PART NO. HARDIN FOR GEN 4 SEA PUMPS: REPLACEMENT REBUILD KITS 11 Industry Dr. Palm Coast, FL 32137 MARINE 625-4100 386-445-2500 / FAX 386-445-1122 GEN 1: 625-4103 625-4173 MASTER REBUILD KIT TITI F: 625-4105 625-4179 IMPELLER KIT HARDIN GEN 4 SEA PUMP VERSIONS 625-4106 625-4107 **GEN 2:** www.hardin-marine.com 625-4109 625-4174 MASTER REBUILD KIT 625-4110 625-4189 IMPELLER KIT 625-4118

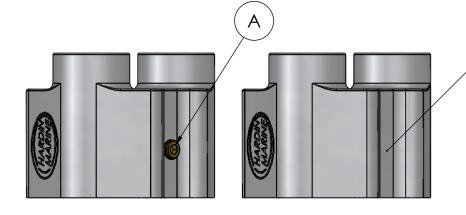
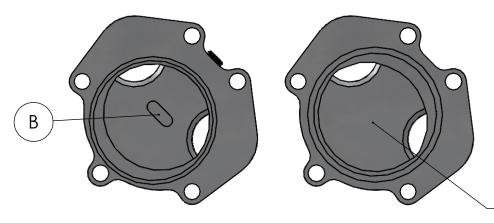
-PIPE PLUG NOT USED IN GEN 2

FOR ALL HARDIN MERCURY GENERATION 4
REPLACMENT SEA PUMPS YOU CAN IDENTIFY
WHETHER YOU HAVE THE FIRST OR SECOND
VERSION OF THESE PUMPS BY SIMPLY
IDENTIFYING WHETHER YOUR PUMP HAS A
1/8"NPT BRASS DRAIN PLUG LOCATED ON THE
UNDERSIDE OF THE PUMP HOUSING BETWEEN
THE INLET/OUTLETS OF THE HOUSING, SEE FIG
A. IF THE HOUSING IS OFF THE PUMP GEN 1
HAD A SLOT IN THE BODY. SEE FIG B.

GEN 1 UP TO 12/2012 GEN 2 01/2013 AND UP -NO TAB USED IN GEN 2
